GENERAL INFORMATION

Request: 1) Rezoning from B-2 General Business to RM-100(PD)
High-Density Residential (Planned Development);
2) Preliminary and final development plans for a five-story,
128-unit senior apartments and 1,500 square feet of
commercial space

Case PL2023-178

Project Description: Rezoning from B-2 General Business to RM-100(PD) High-Density Residential (Planned Development); preliminary and final development plans for a five-story, 128-unit senior apartments and 1,500 square feet of commercial space

Figure 1: Existing and Proposed Zoning Designation

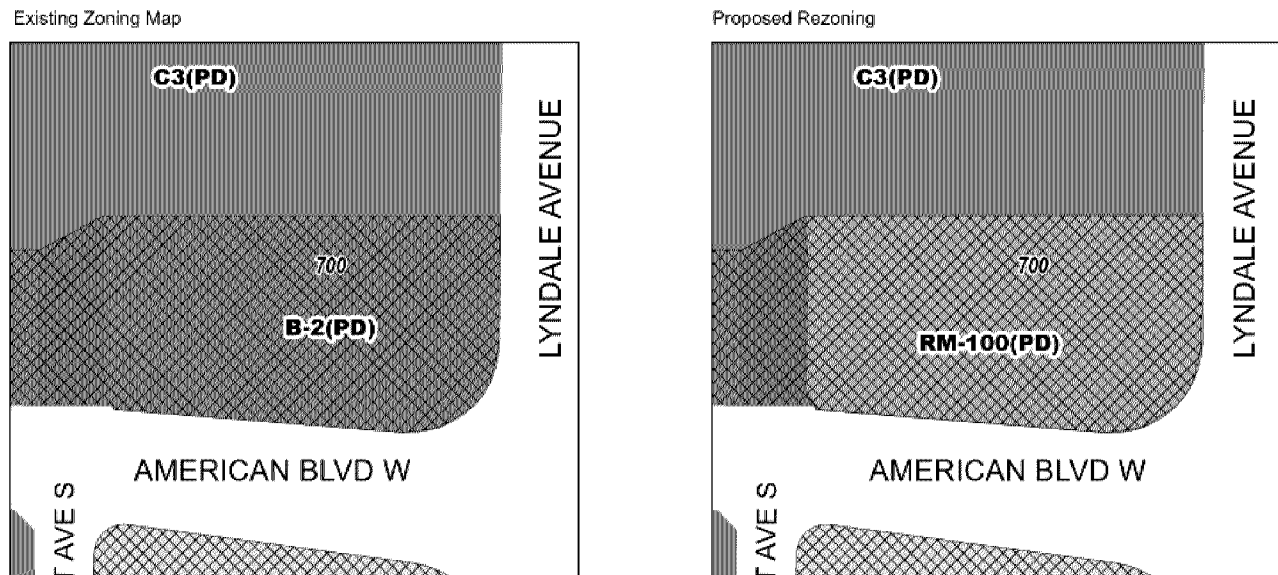
Figure 1 depicts the existing and proposed zoning designation. The property must be rezoned to accommodate the proposed development as the existing B-2 Zoning District applicable to the site does not allow residential uses.
